717-733 Mount Pleasant Road Committee of Adjustment Application

From: Director, Community Planning, North York District

File Number: A0237/23NY

Hearing Date: July 27, 2023

A2-01

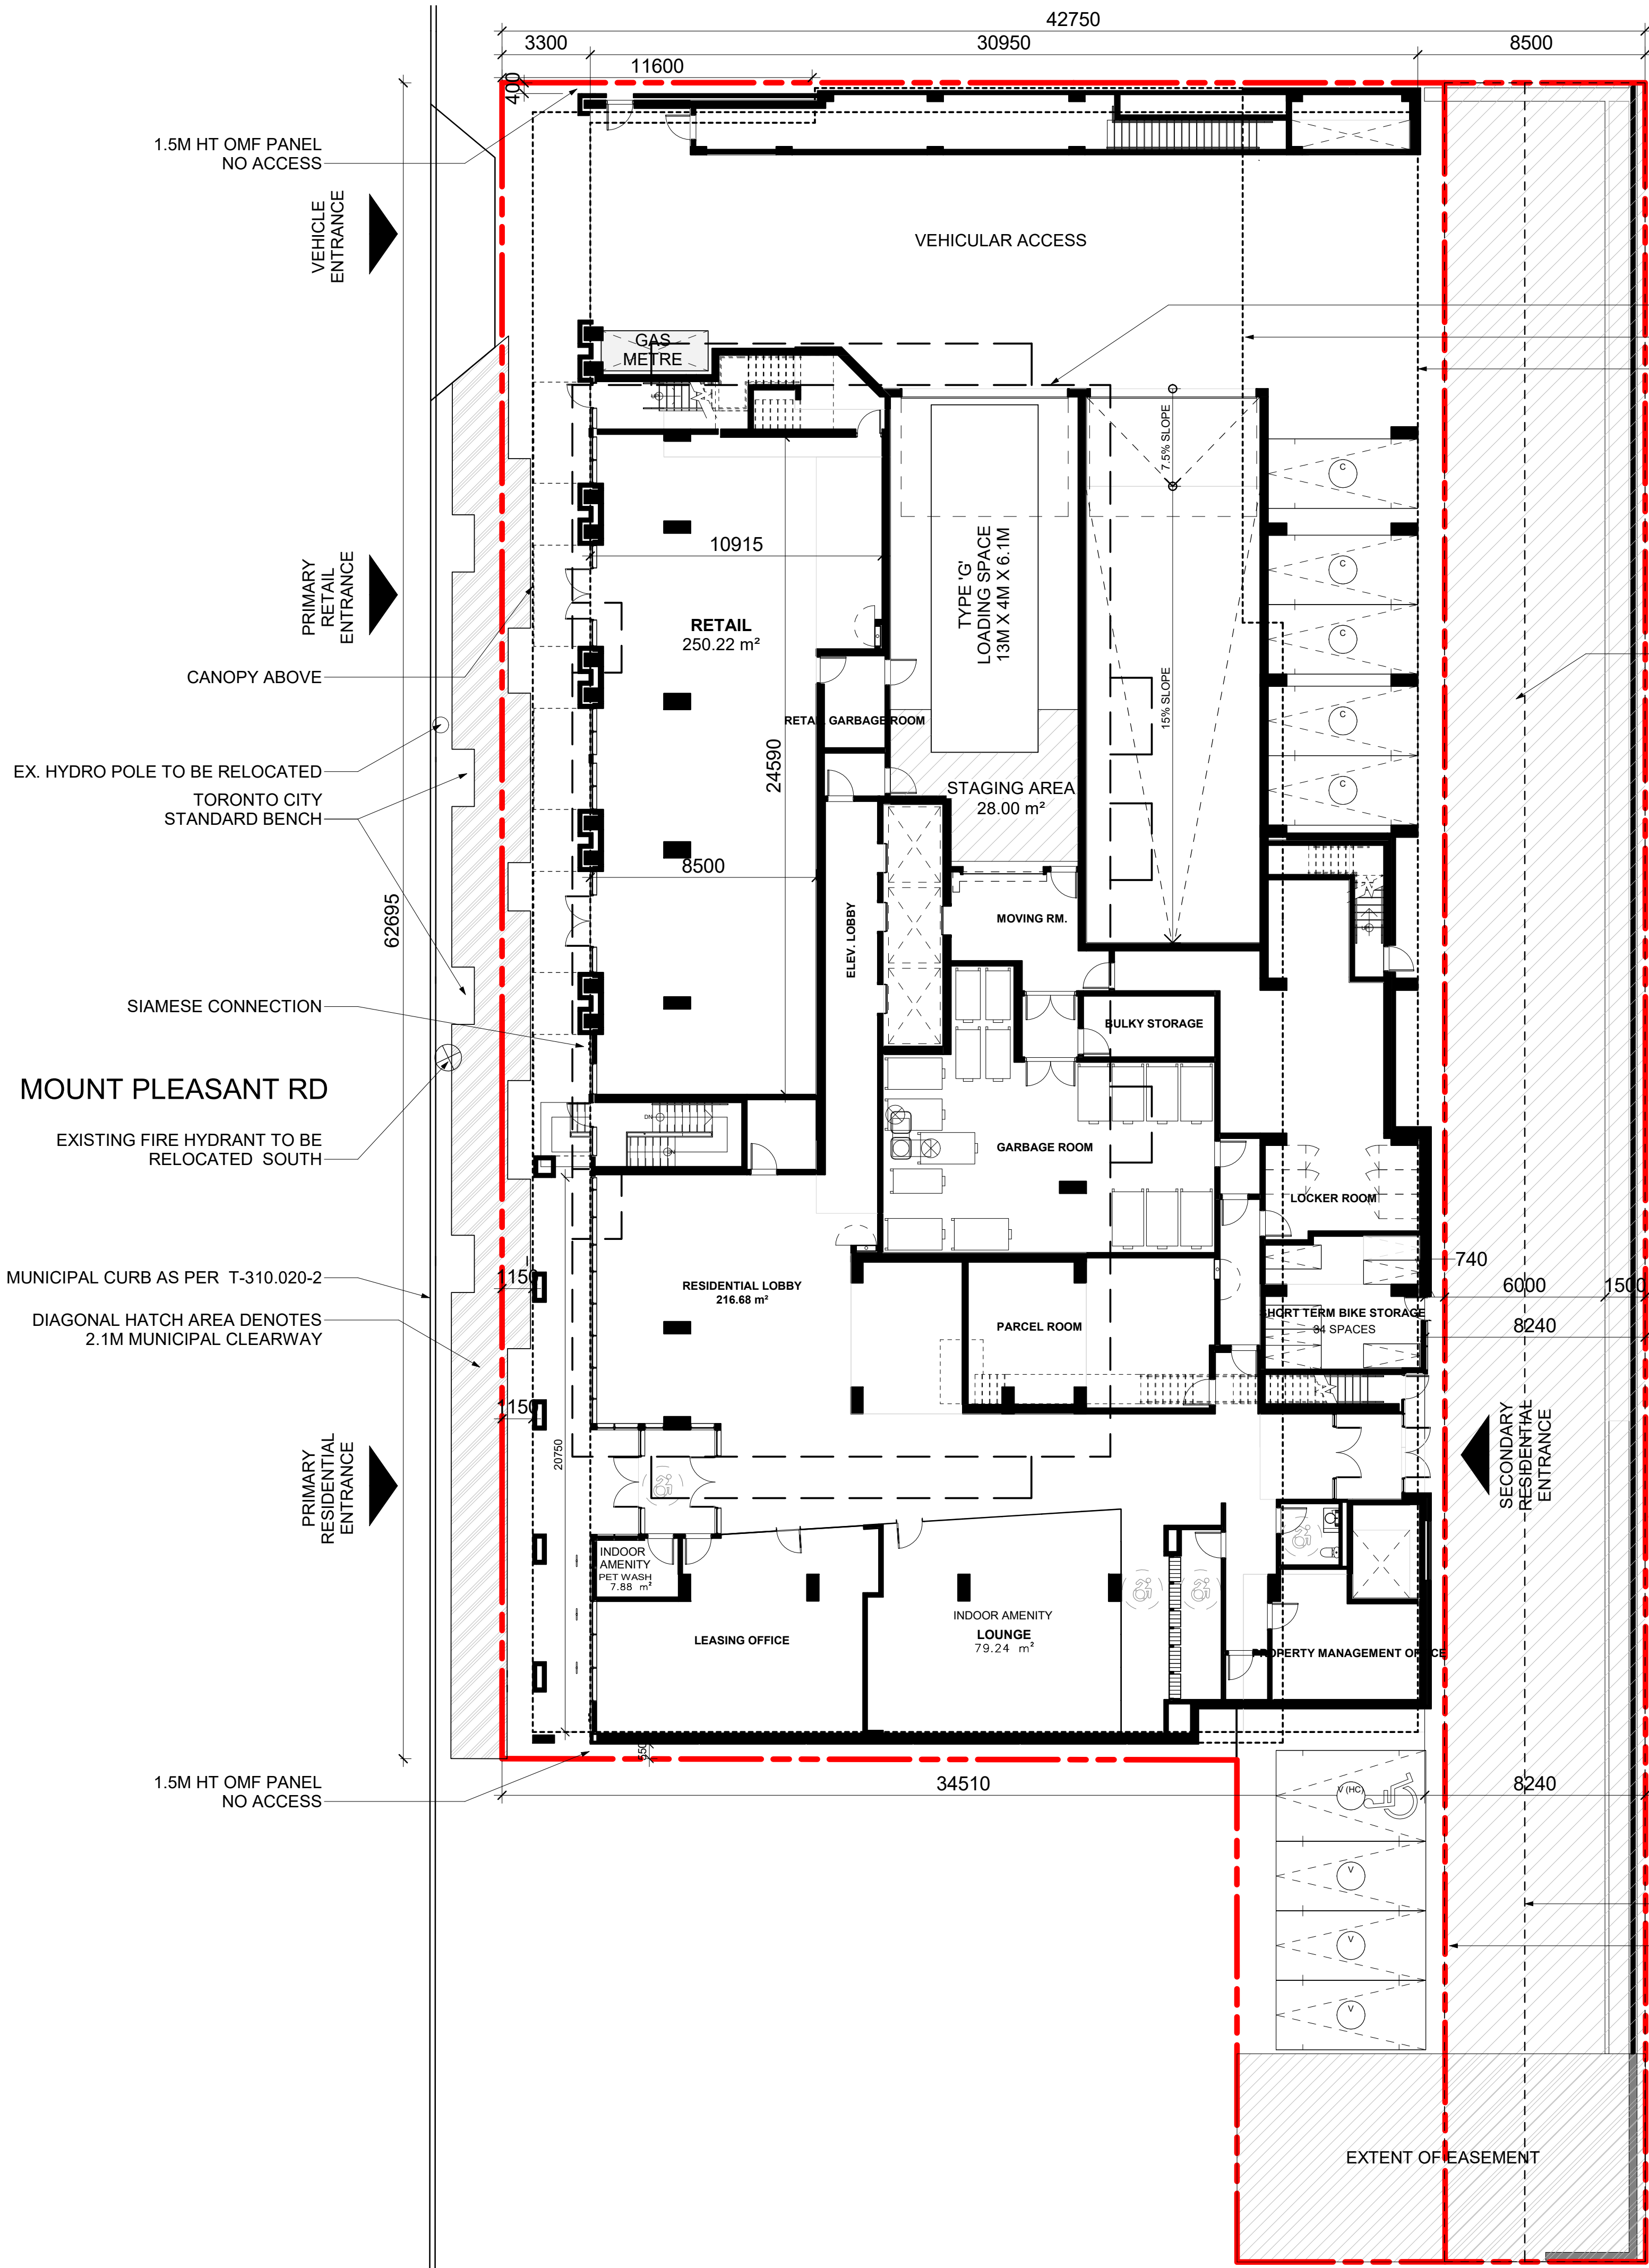
4. That at the northwest corner of the site only, up to a height of 19.0 metres above established grade, the building setbacks to the north and west lot lines, be in accordance with Drawings A2-01 to A2-06 appended as Attachments 1 to 6 of this report;

- the building cut-out located at the northwest corner of the building up to a height of 19.0 metres above established grade; and the floorplates on levels 6 and 7.

A2-06

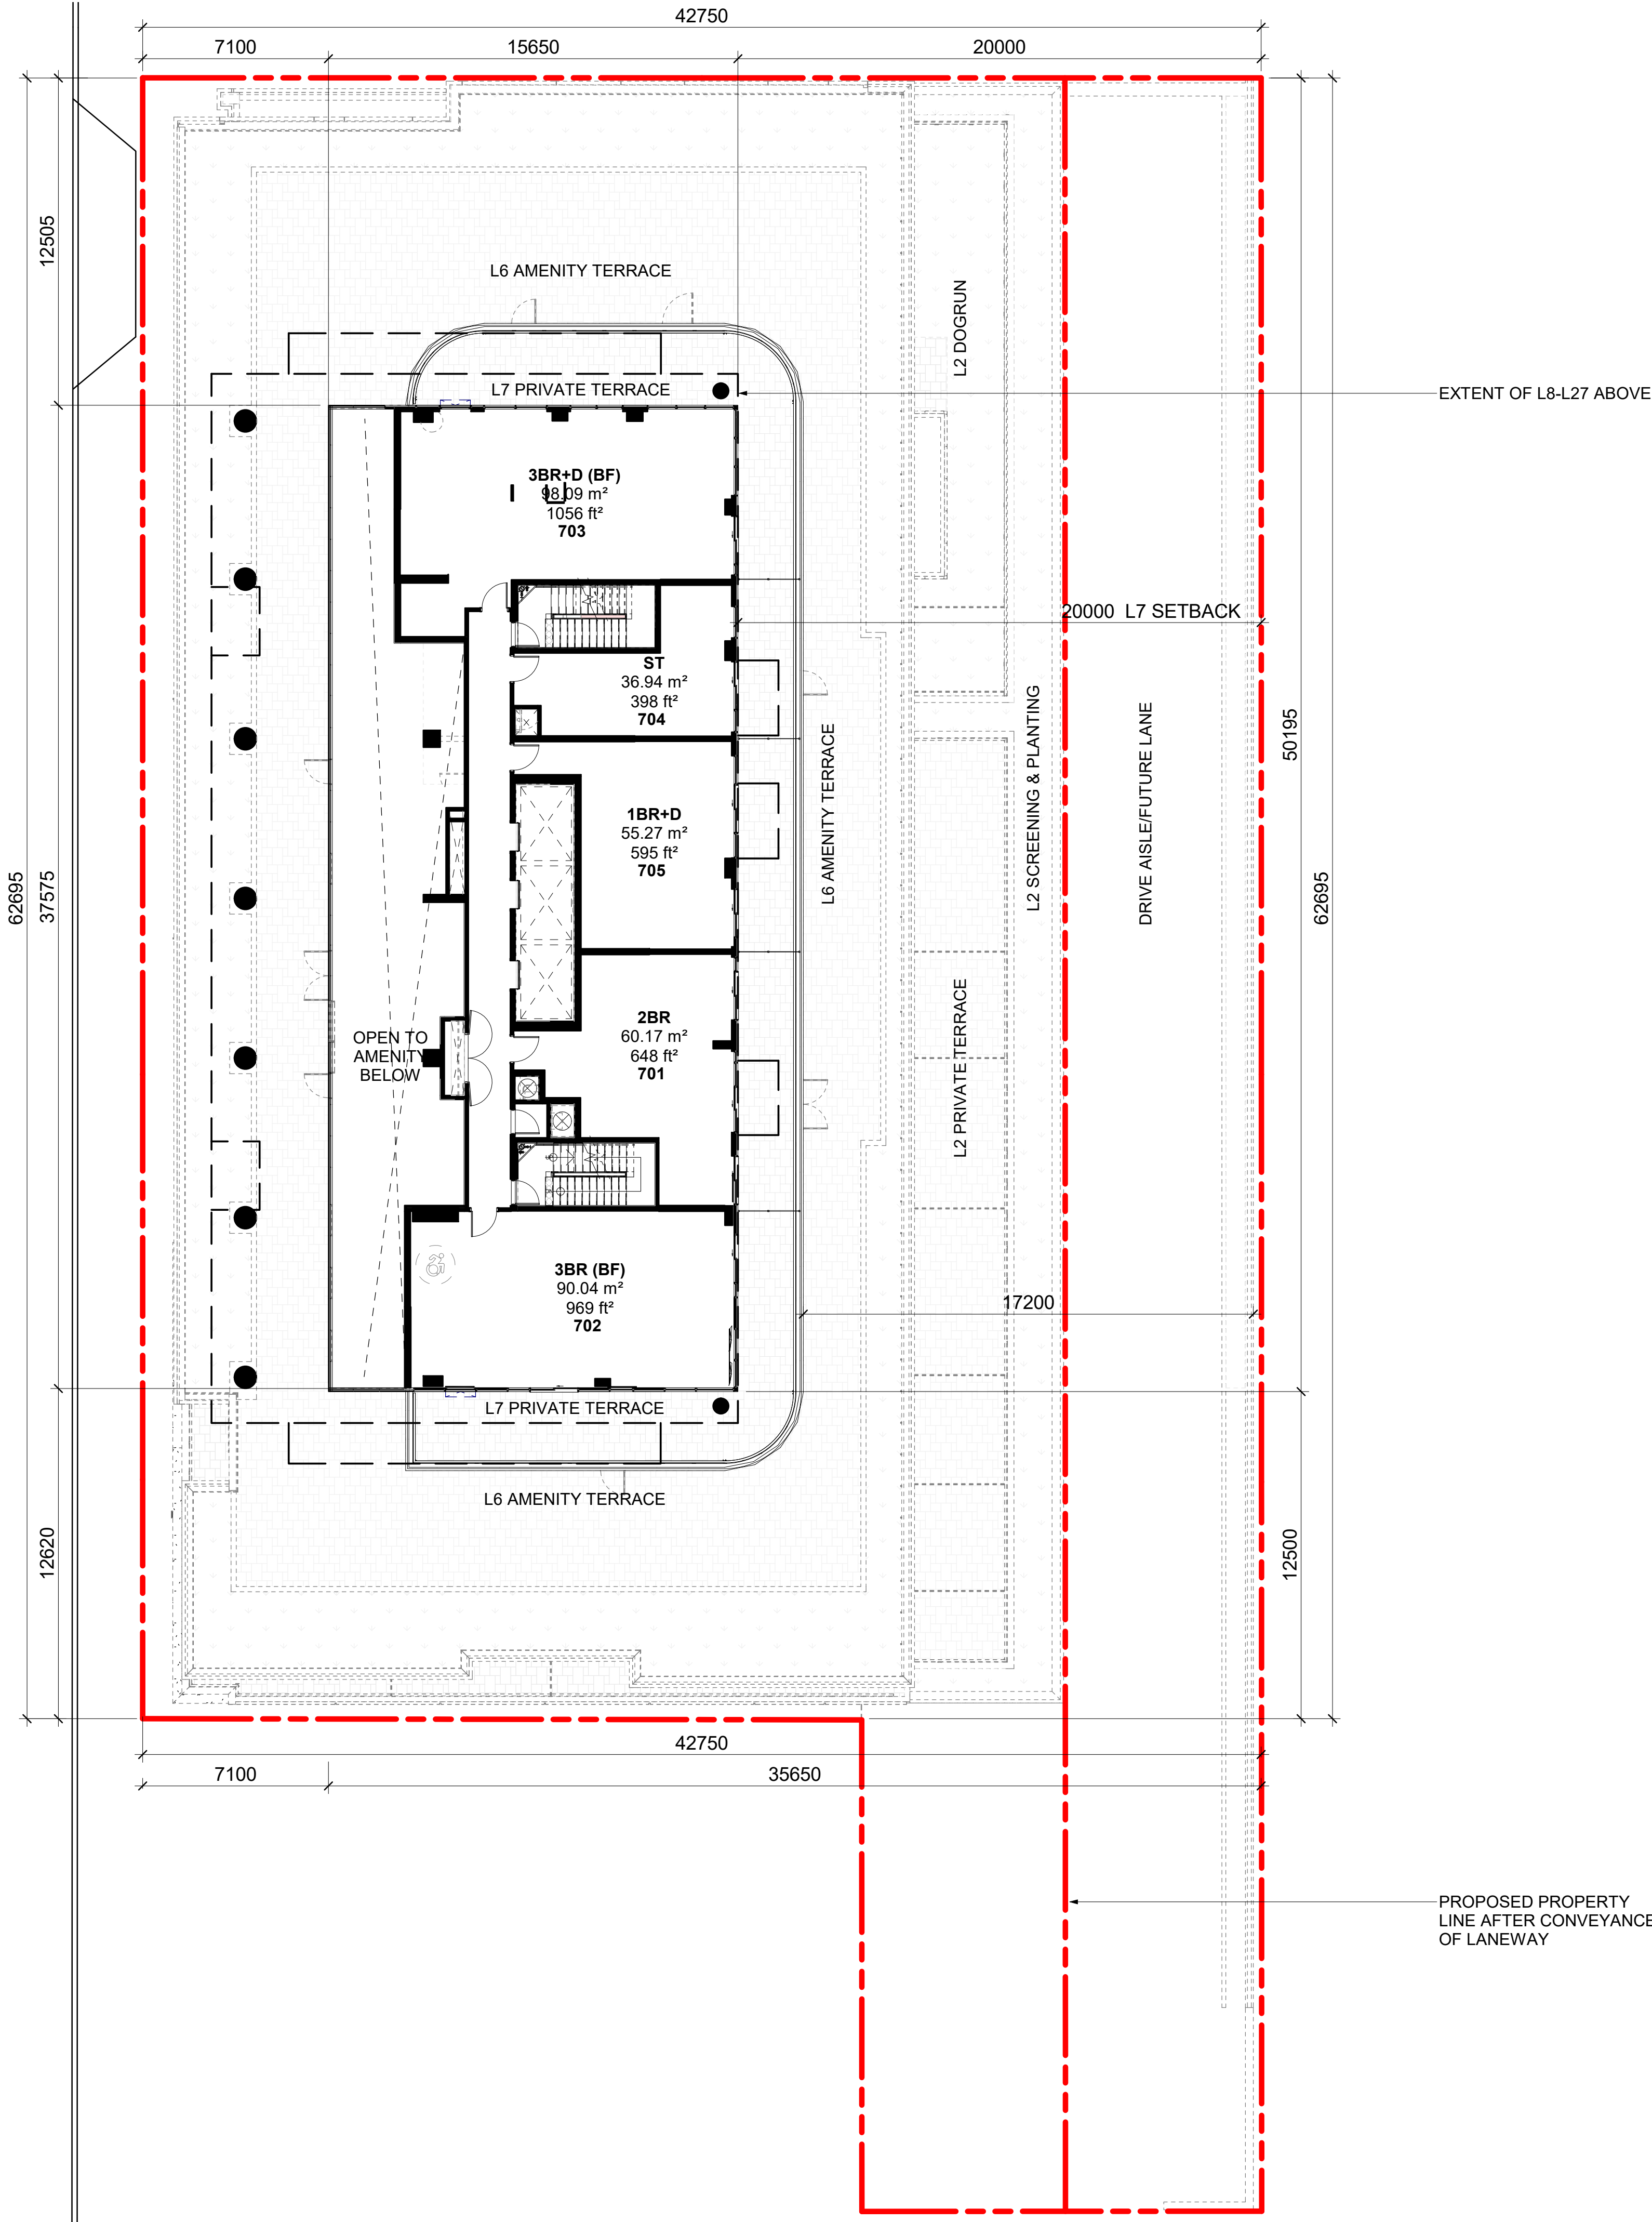
5. That the building setbacks on floors 6 and 7, be in accordance with Drawings A2-06 and A2-07 appended as Attachments 6 and 7 to this report; and
